ADDENDUM NO. ONE
FERNDALÉ PUBLIC SCHOOLS
2017 SINKING FUND PROJECTS
SUMMER 2019 RENOVATION PROJECTS
Page 1 of 2 (write up only)

February 8, 2019

ADDENDUM NO. ONE to the plans and specifications for the FERNDALÉ PUBLIC SCHOOLS, 2017 SINKING FUND PROJECTS, SUMMER 2019 RENOVATION PROJECTS, Ferndale, MI, Architect's Project No. 181794, dated February 1, 2019.

4 CORRIDOR ELEVATION
 A1.0UE SCALE: 3/4" = 1'-0"

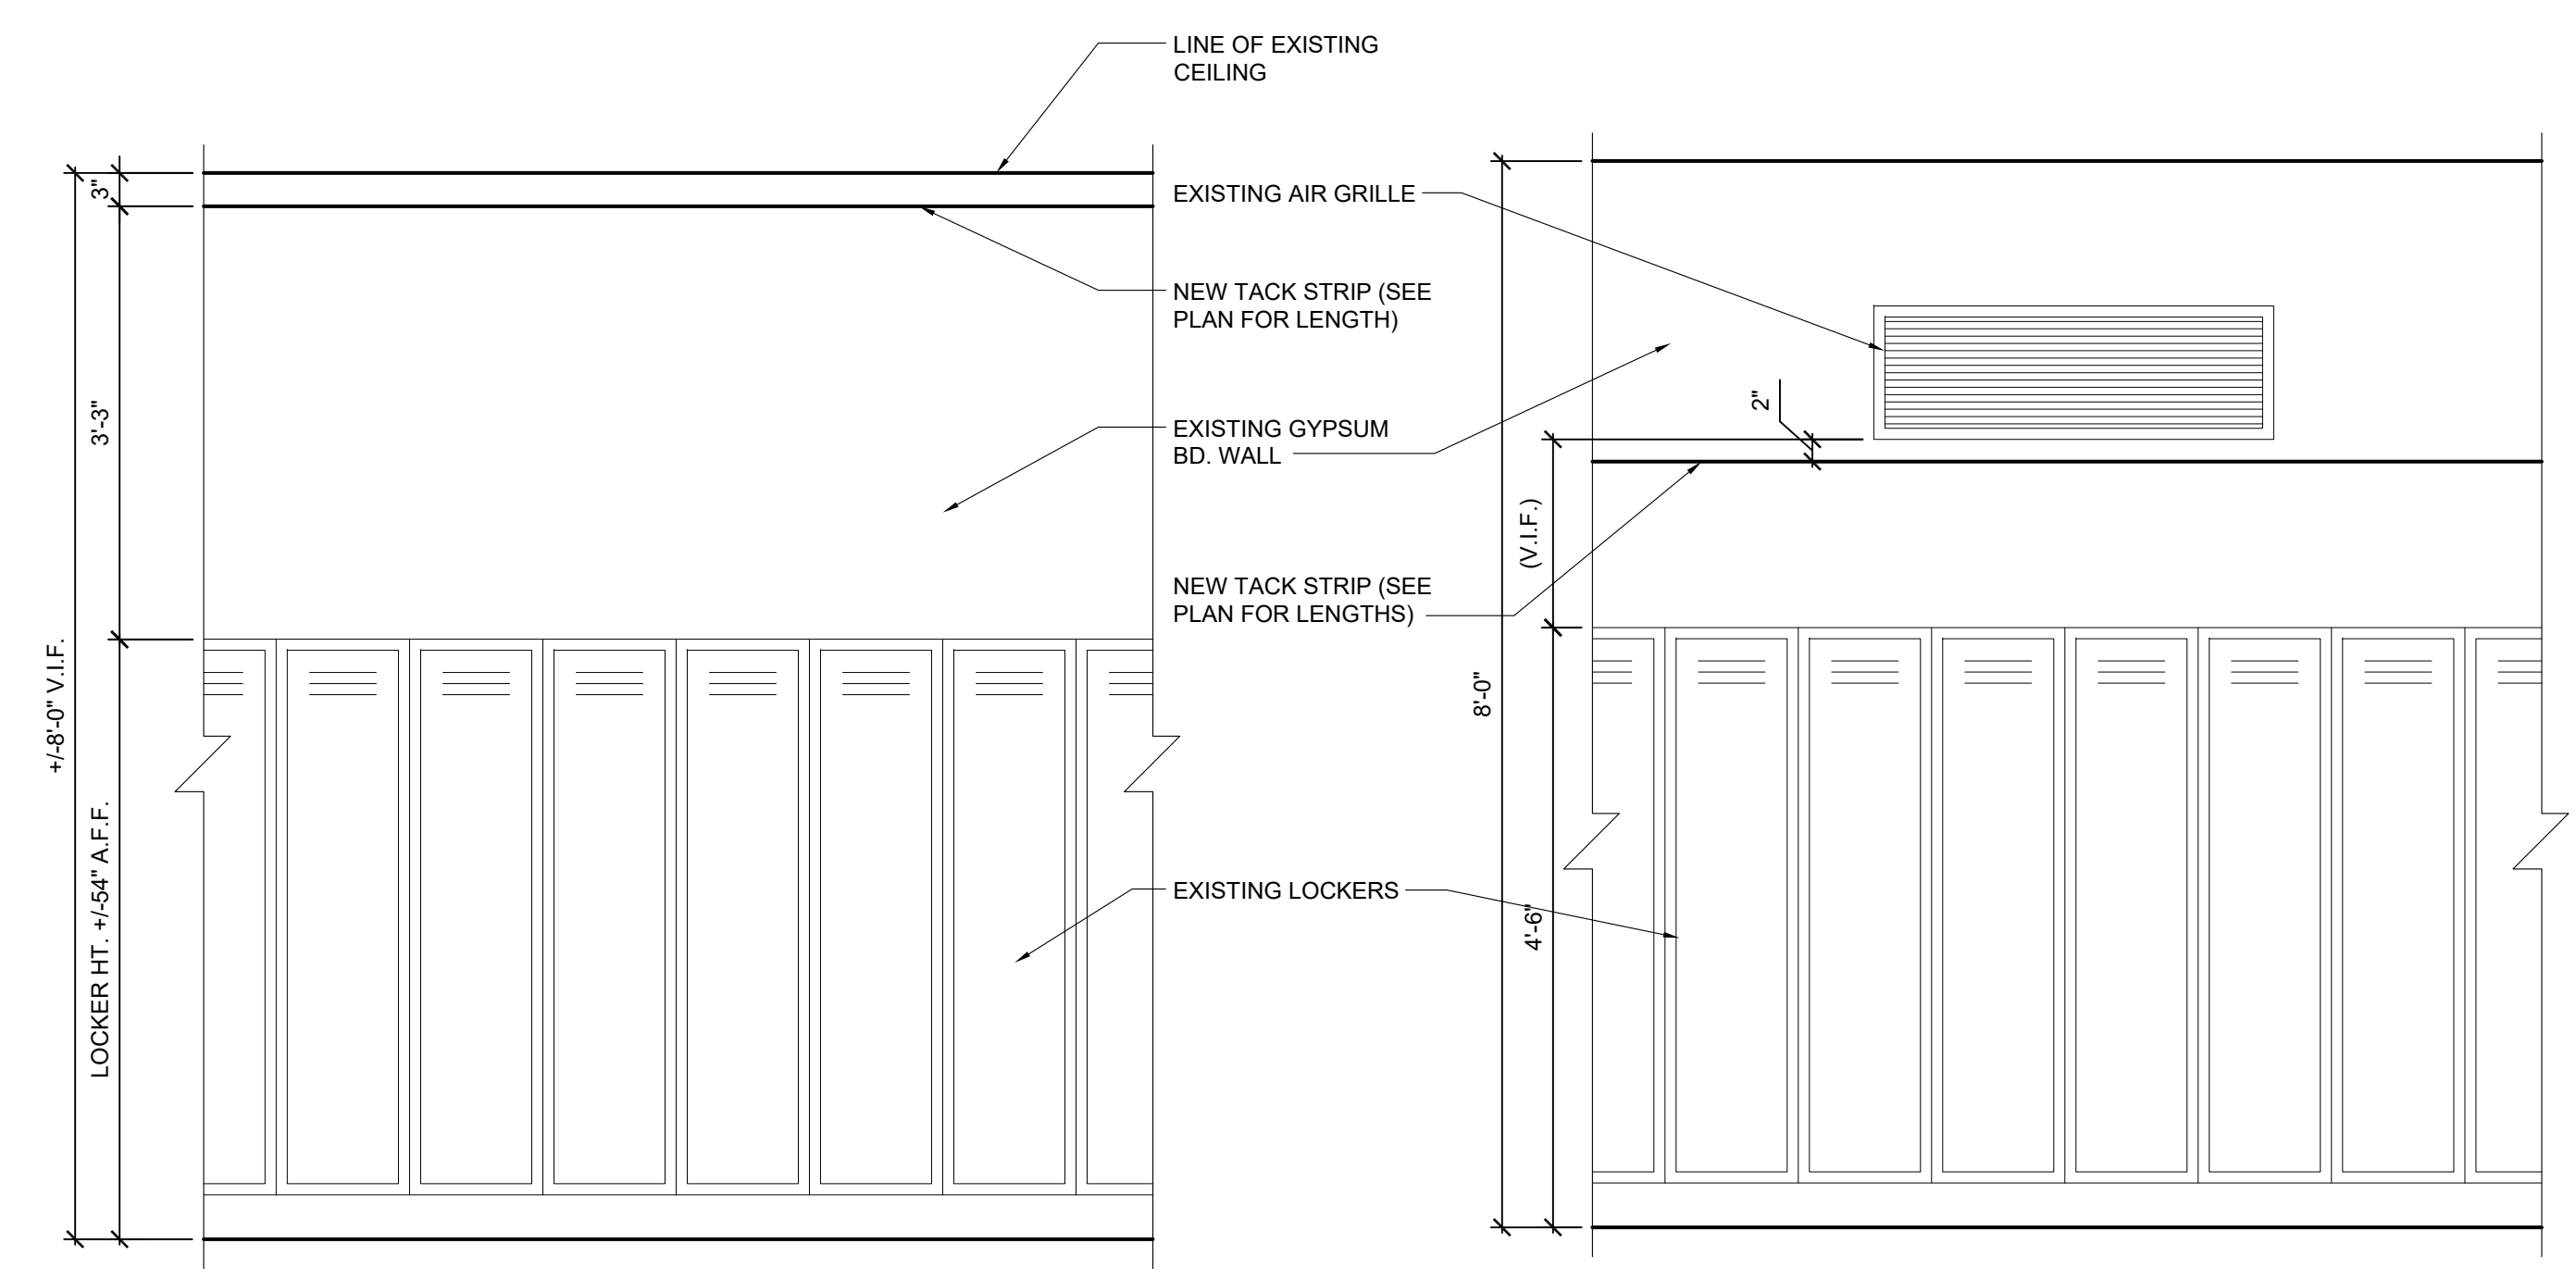
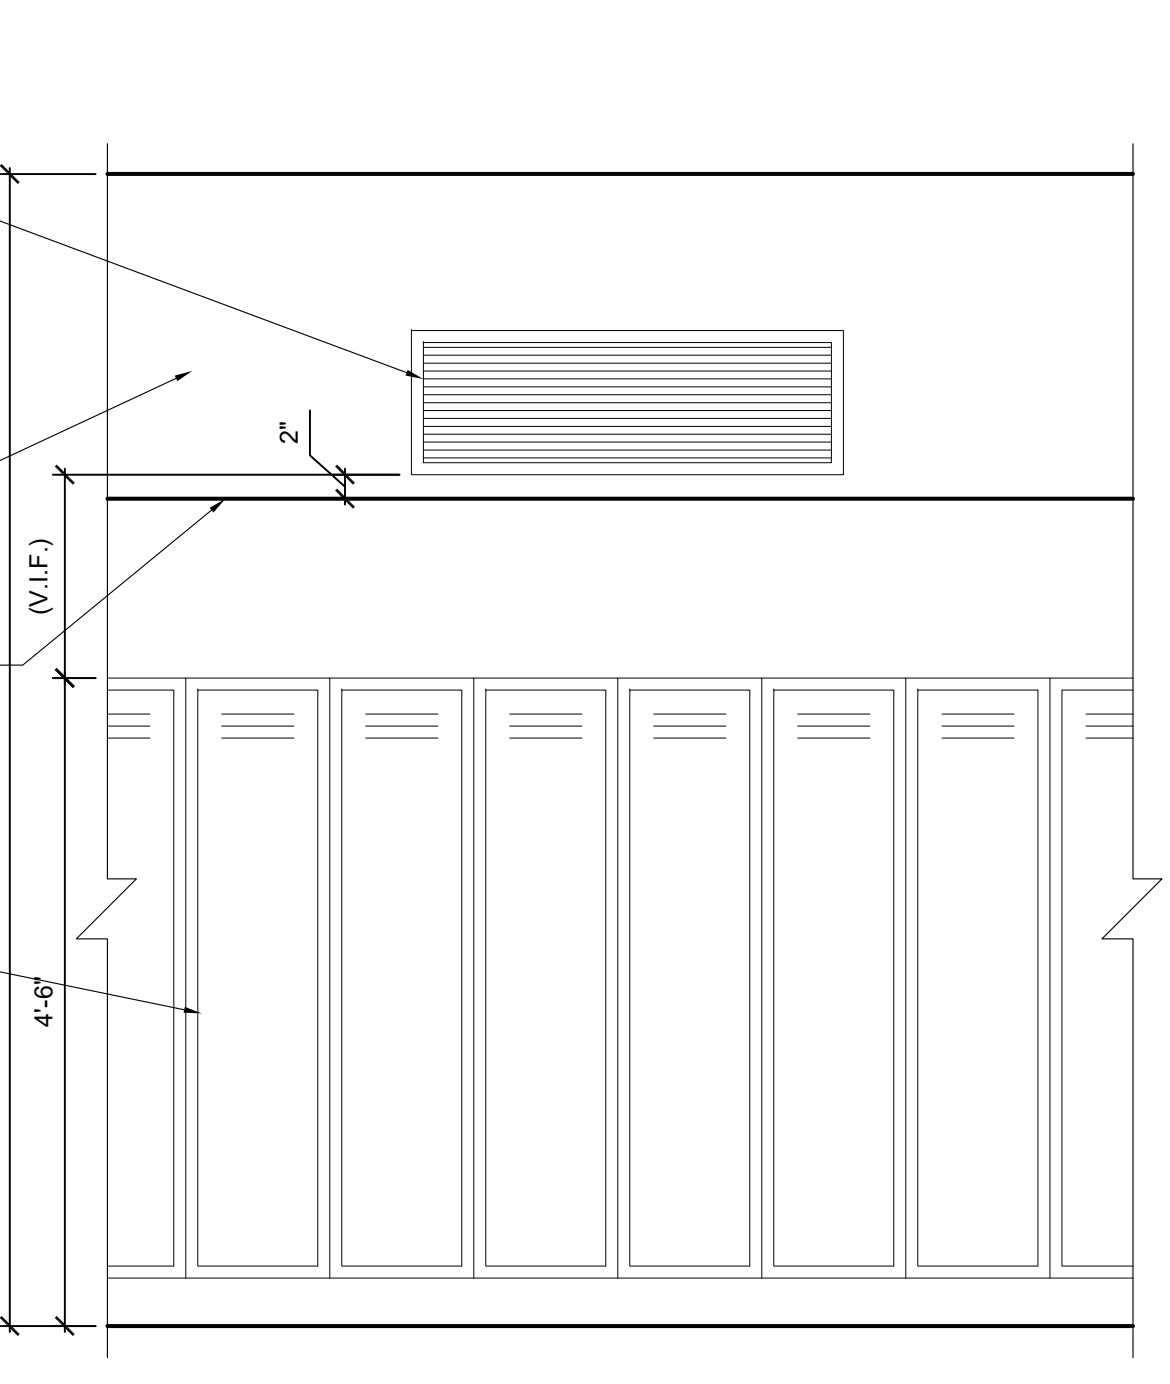
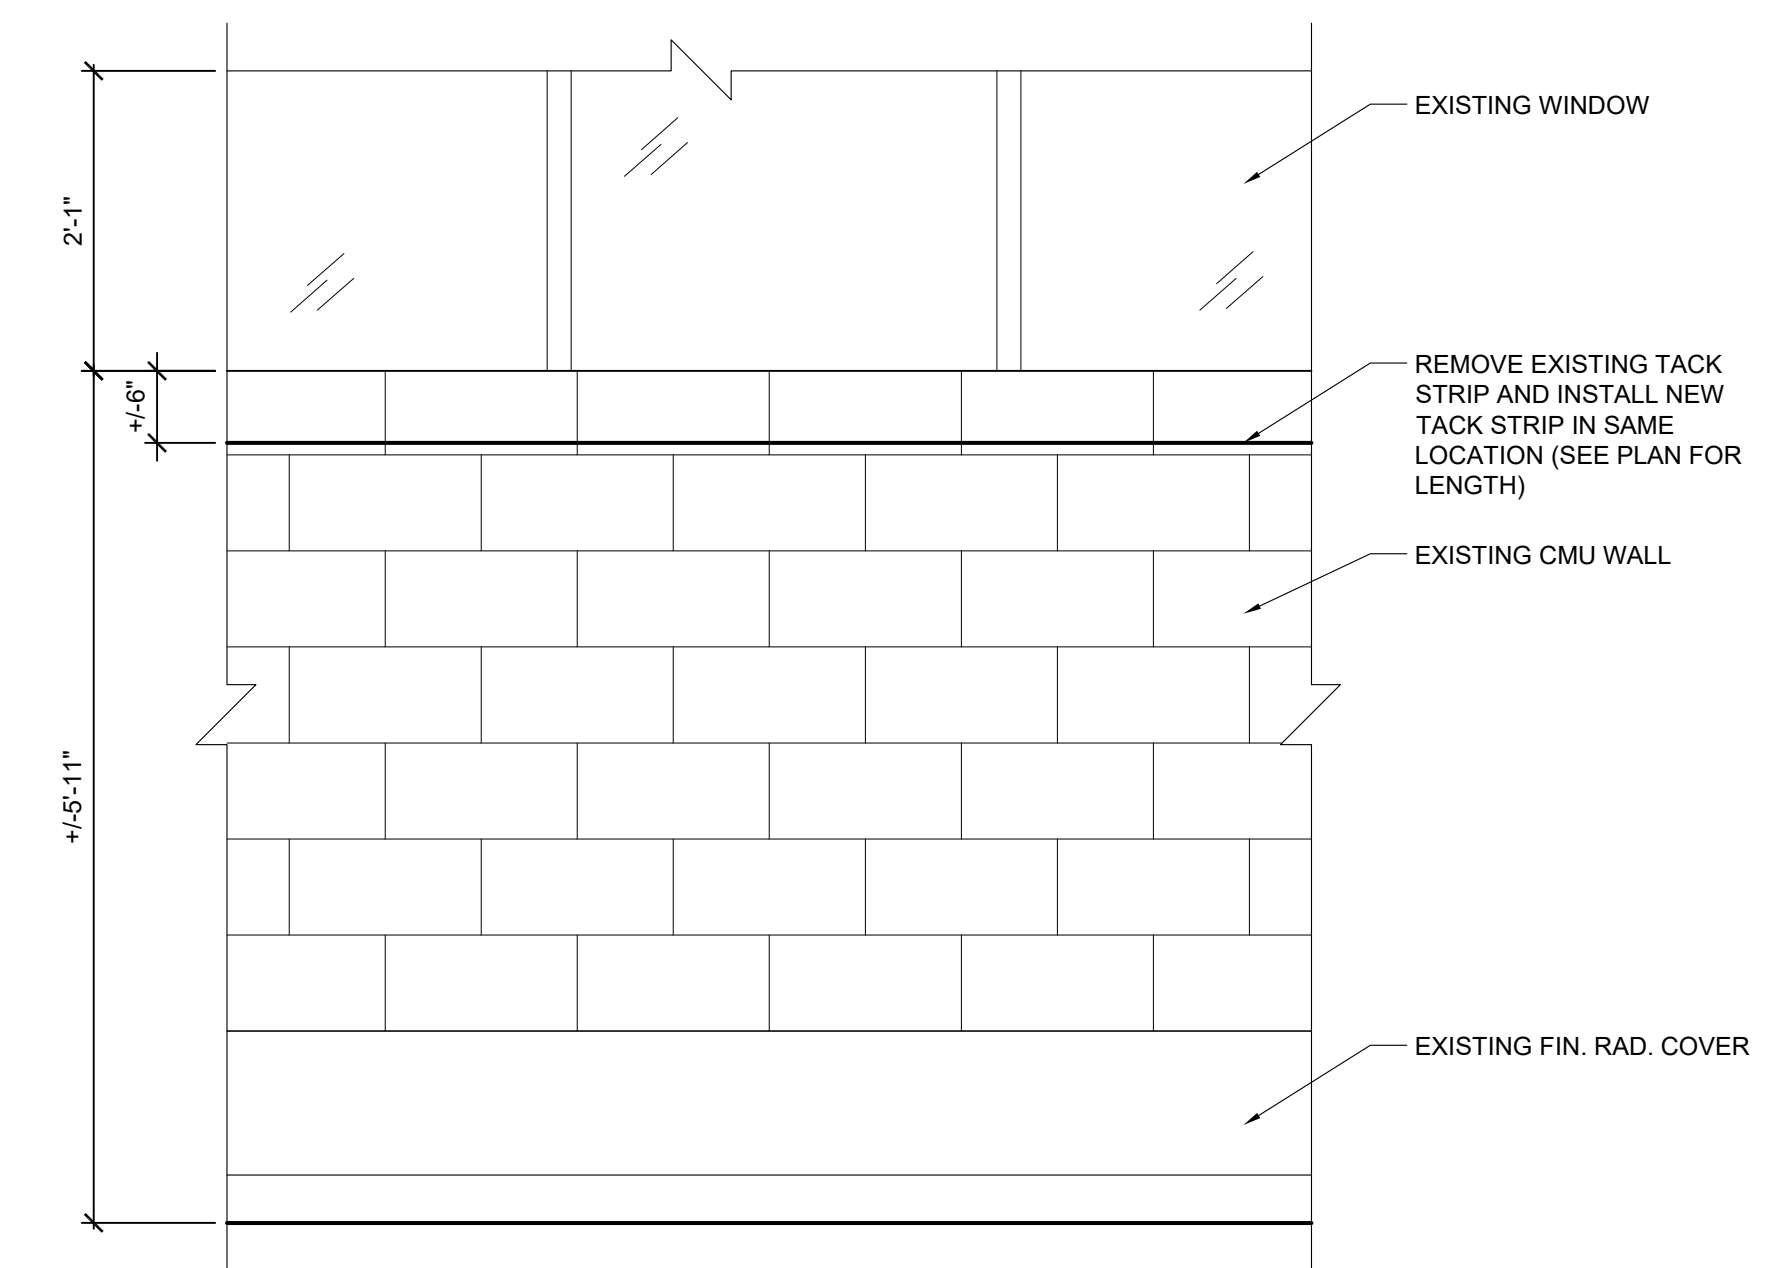
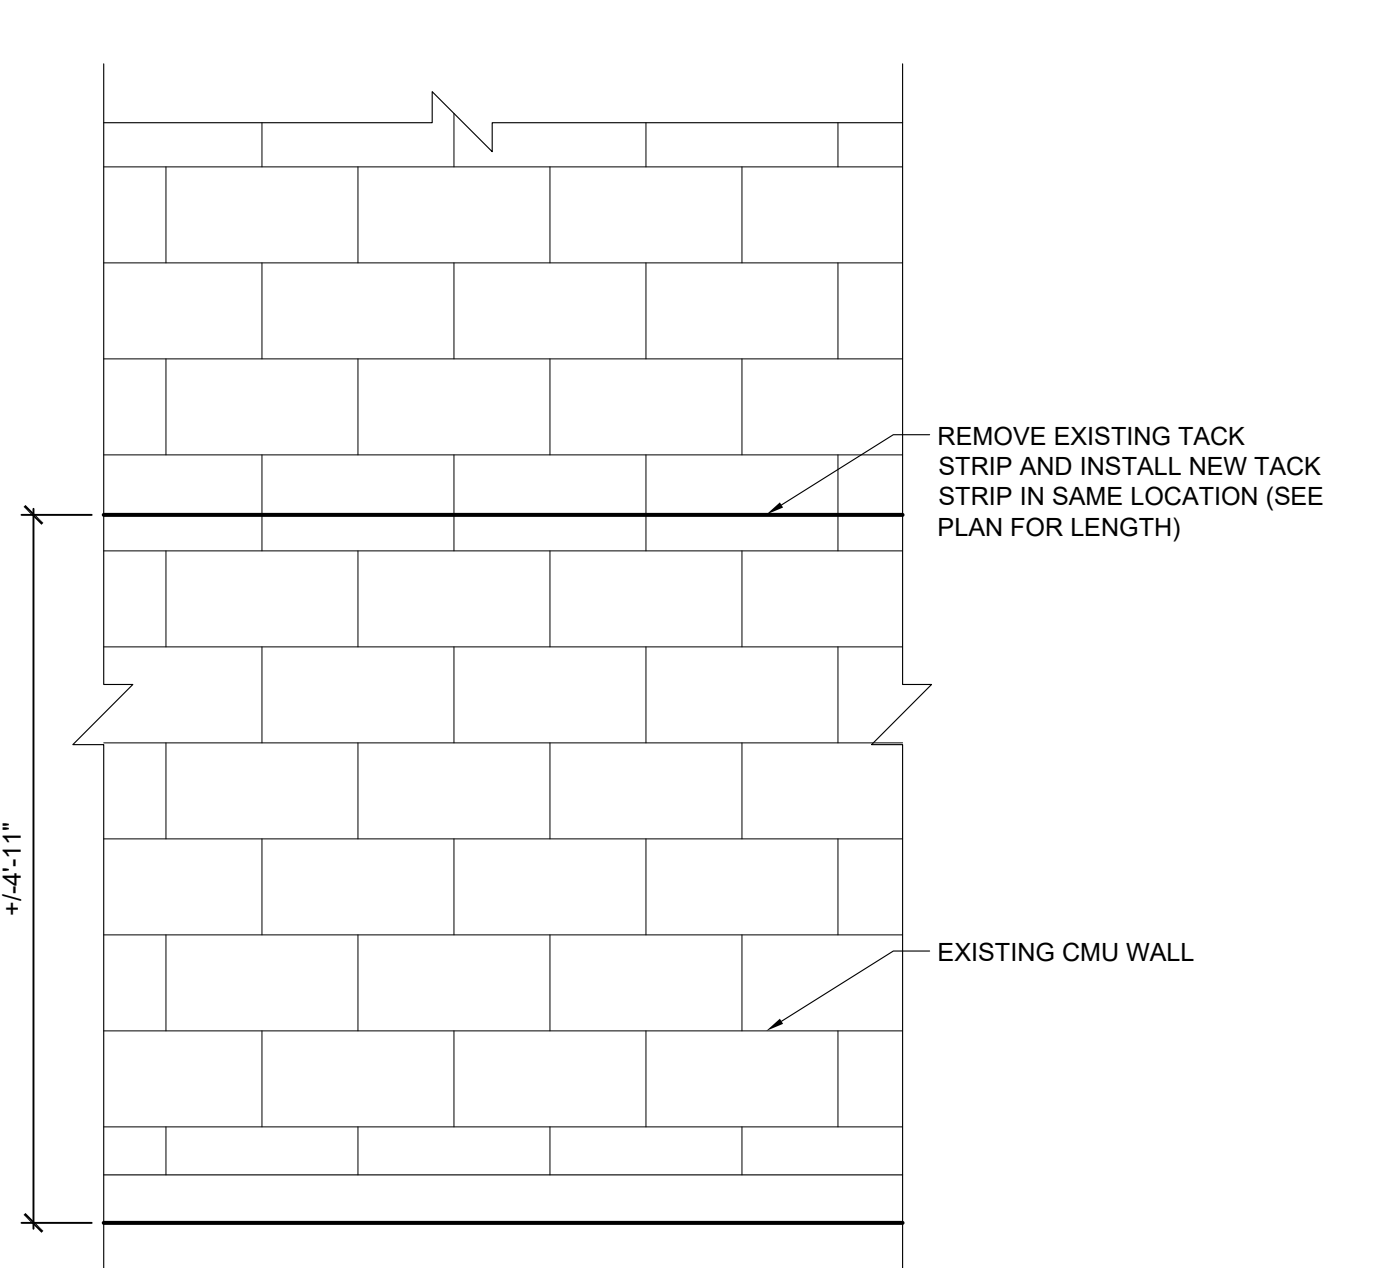
- ITEM NO. A1:** Refer to Drawing No. A1.0LE (re-issued):
- a. Refer to attached drawing no. A1.0LE for the locations of detail no. 2.
- ITEM NO. A2:** Refer to Drawing No. A1.0UE (re-issued):
- a. Refer to attached drawing no. A1.0UE for revised note no. 1.
- ITEM NO. A3:** Refer to Drawing No. A1.1UH (re-issued):
- a. Refer to attached drawing no. A1.1UH for location of typical detail no. 2.
- ITEM NO. A4:** Refer to Drawing No. A1.0H (re-issued):
- a. Refer to attached drawing no. A1.0H for revised New Work Note 29.
